## DENDROBIUM MINE EXTENSION PROJECT: SUBMISSION

14 June 2022

Thank you for the opportunity to make a submission. Lock the Gate Alliance **objects** both to this development application and to this bespoke assessment and determination process.

**Figure 1: Comparison of the last five years of Scope 1 emissions reported to the CER with average annual Scope 1 emissions predicted for the Dendrobium Mine Extension**

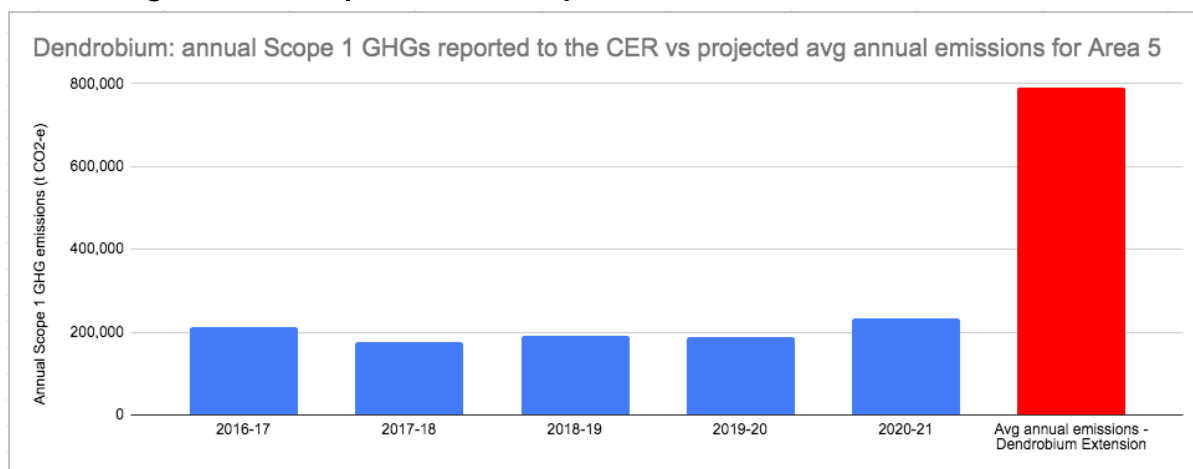
Based on the average Scope 1 emissions (assuming flaring) of 789,551 tonnes CO2-e per annum, **the Dendrobium Extension could become the 4th highest emitting coal mine in NSW**. In 2020/21, 24 coal mines in NSW emitted more than 100,000 t CO2-e, but only three mines emitted more than 789,551 tonnes with the highest emitting mine being IMC's other mine at Appin. As the Project is proposing to extract from Area 5 which has "a higher gas concentration", the Extension project would **more than triple current Scope 1 GHG emissions**.

Even in the 5 years post mining, legacy Scope 1 emissions are projected to be more than 100,000 t CO2-e per annum higher (at 351,437 t CO2-e) than those currently being reported by Dendrobium to the Clean Energy Regulator in Canberra.<sup>19</sup>
